**WHITE LAKE TOWNSHIP
ZONING BOARD OF APPEALS**

**REPORT OF THE
COMMUNITY DEVELOPMENT DEPARTMENT**

Agenda item: 8c

Location: 10890 Hillway Drive
White Lake, MI 48386

A-1

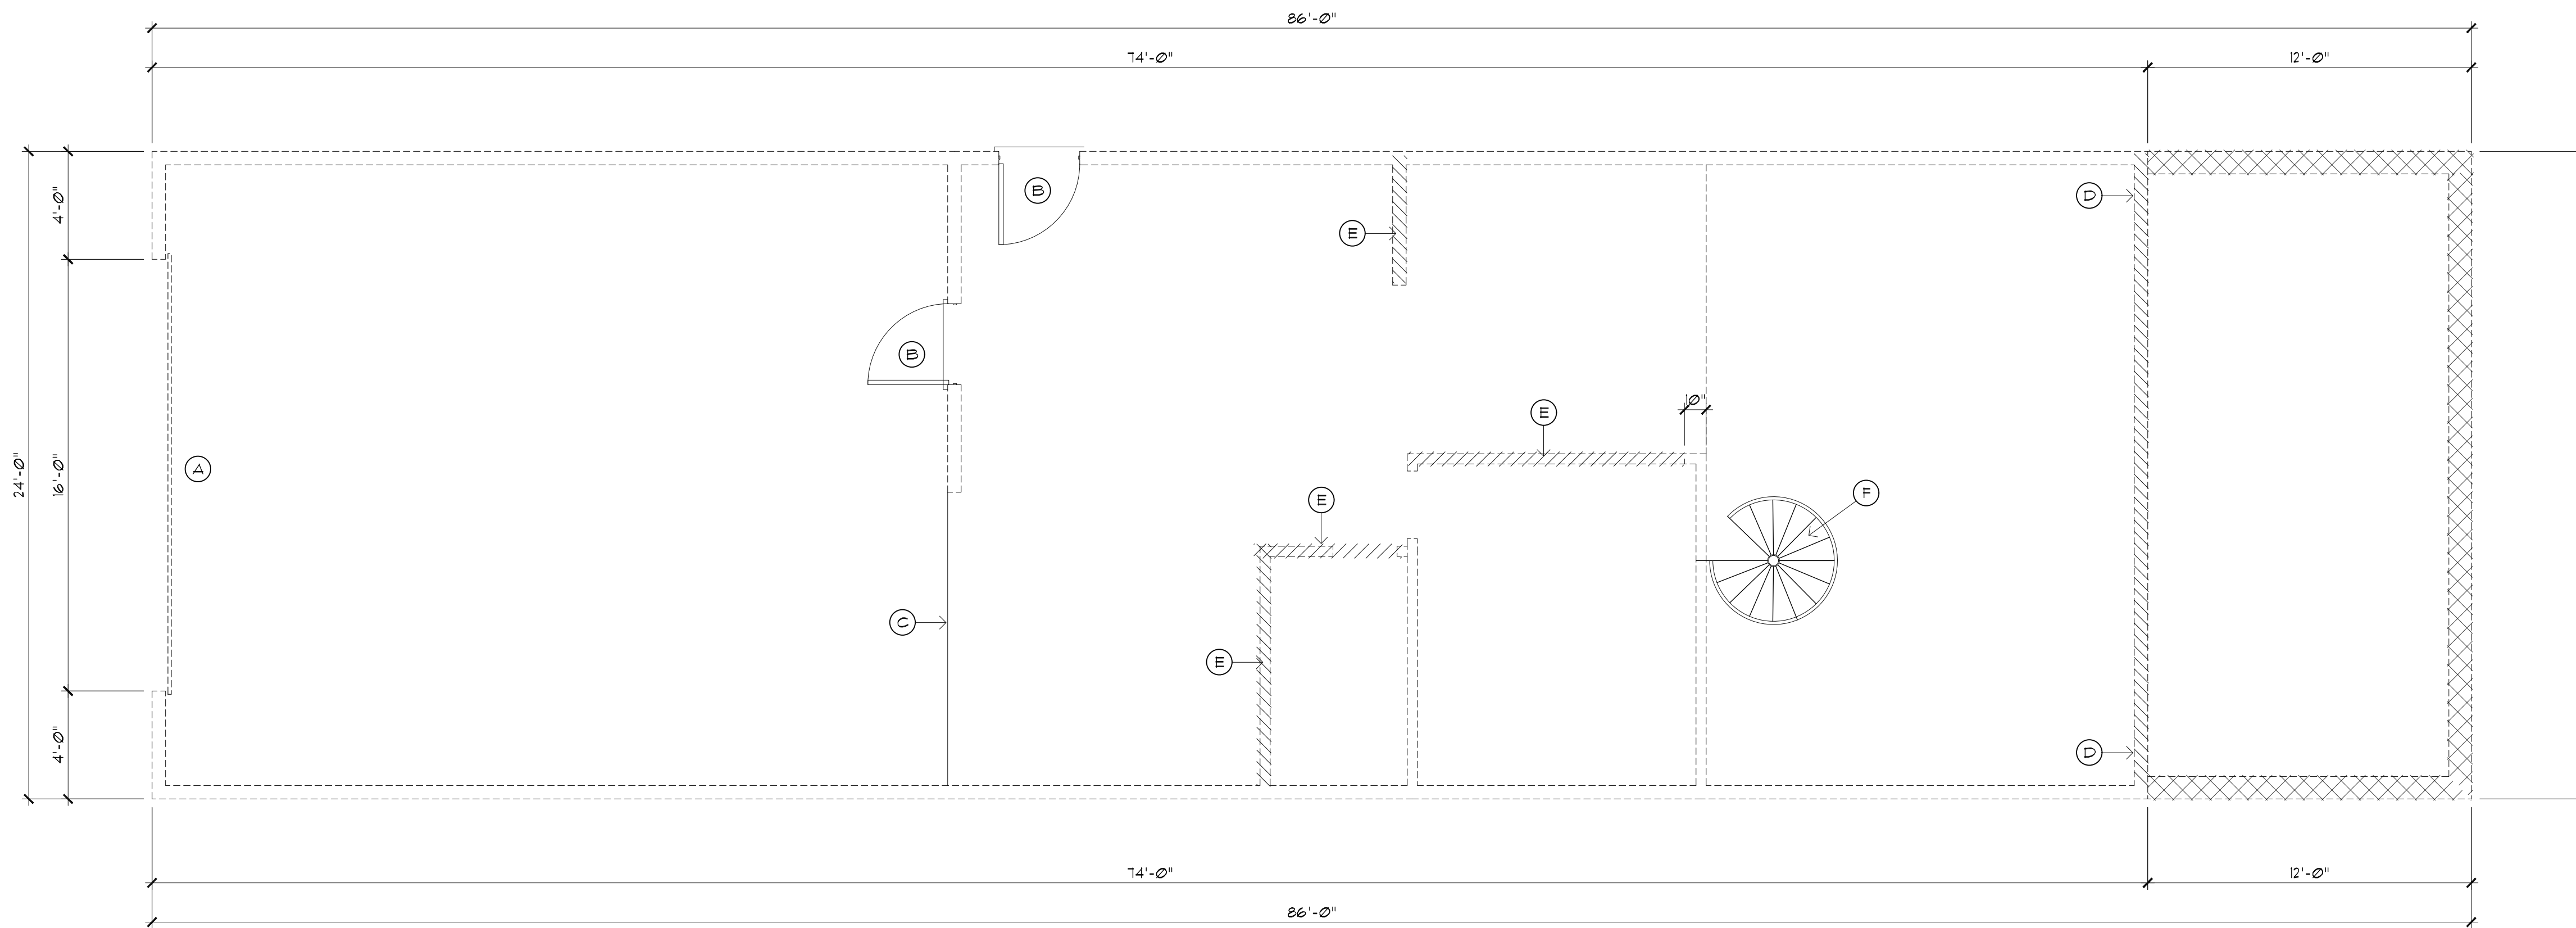
Currently the existing house is nonconforming to setbacks; based on the submitted survey, the building is located 7.1 feet from the west side lot line. A minimum 10-foot side yard setback is required in the R1-D zoning district. The parcel is also nonconforming due to a 29.75-foot deficiency in lot width; the minimum lot width requirement is 80 feet in the R1-D zoning district.

Sometime between 2012 and 2014, the previous property owner constructed an unapproved/unpermitted second-story addition and rear covered patio. The unpermitted work did not conform to the required setback from the west property line. Per the submitted plans, the rear covered patio is proposed to be converted to 288 square feet of living space. Currently, the southwest corner of the covered patio is located 7.3 feet from the west side lot line, encroaching 2.7 feet into the required setback. The second story addition would be 508 square feet in size and encroach approximately 2.8 feet into the west side yard setback.

WEST ELEVATION

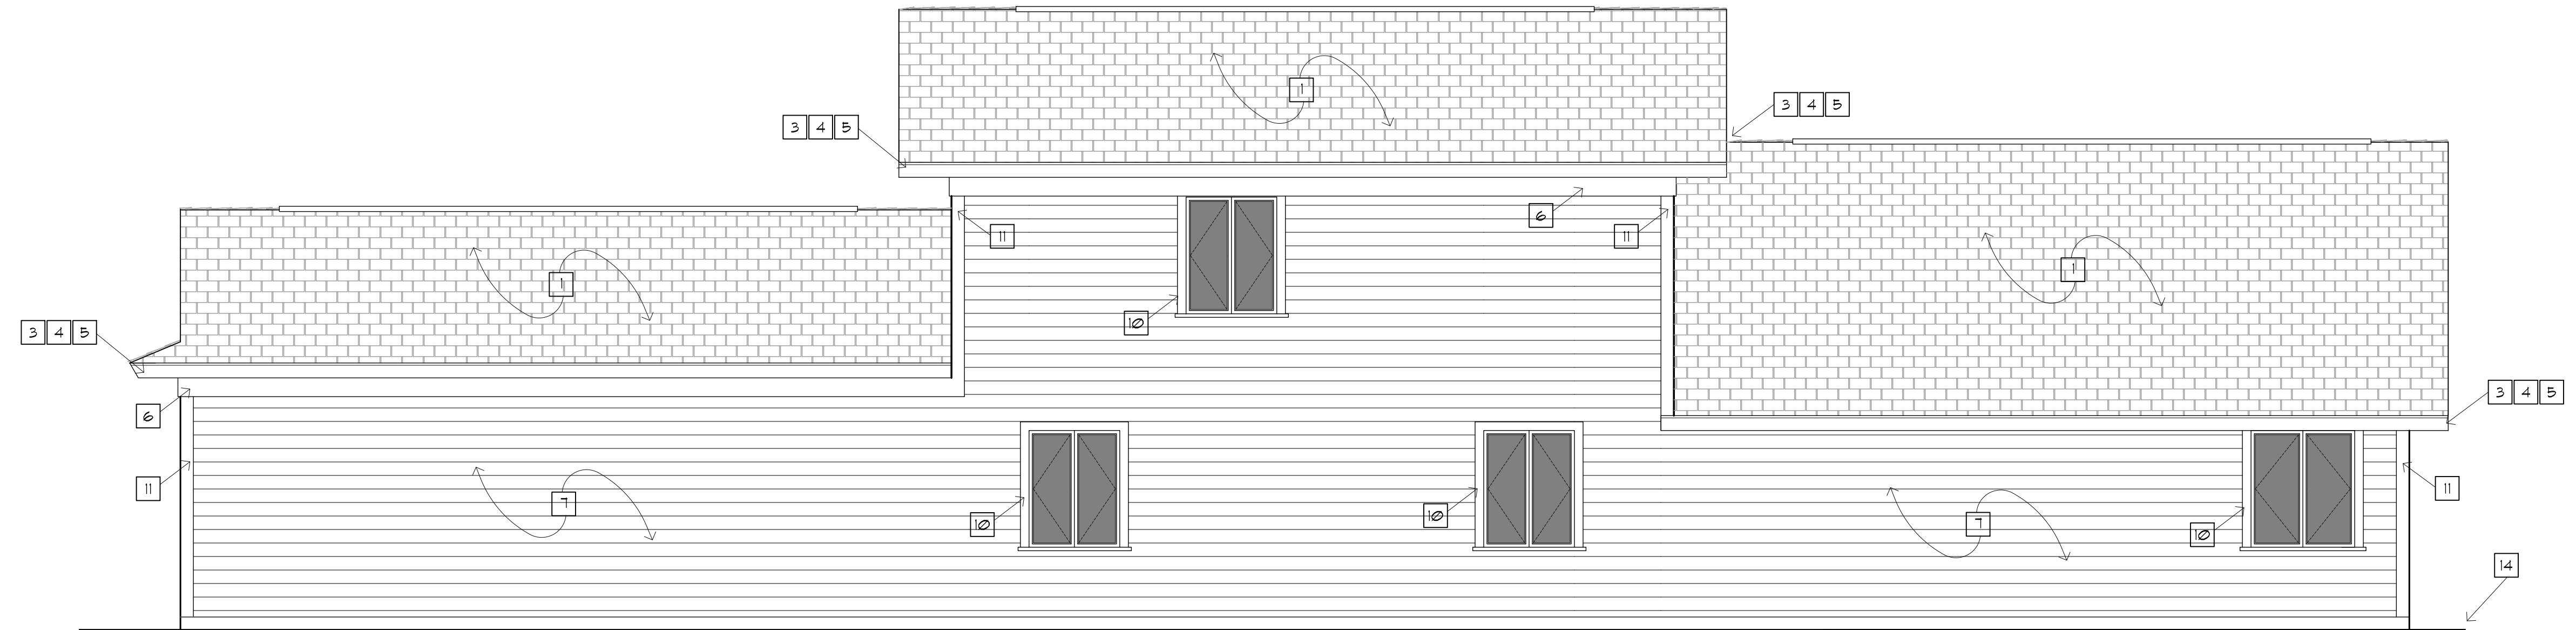
The submitted architectural plans show a proposed covered porch extending approximately four-six feet (extent of projection not dimensioned/labeled on the plans) off the west side of the building. Section 7.27.vii of the Zoning Ordinance prohibits the Zoning Board of Appeals from granting a variance to permit a setback of less than five feet from a side lot line to ensure access for fire equipment and other emergency vehicles. If the Board decides to approve the request, a condition must be revising the architectural plans to eliminate the proposed covered porch.

- The Applicant shall obtain all necessary permits from the White Lake Township Building Division.
- The Applicant shall resubmit architectural plans showing elimination of the proposed covered porch from the west side of the house.
- No mechanical units, including HVAC system or generator, shall be placed in the front yard or closer than five (5) feet to any side yard lot line or rear yard lot line.
- A foundation certificate shall be required prior to the backfill inspection by the Building Division.
- An as-built survey shall be required to verify the approved setbacks.
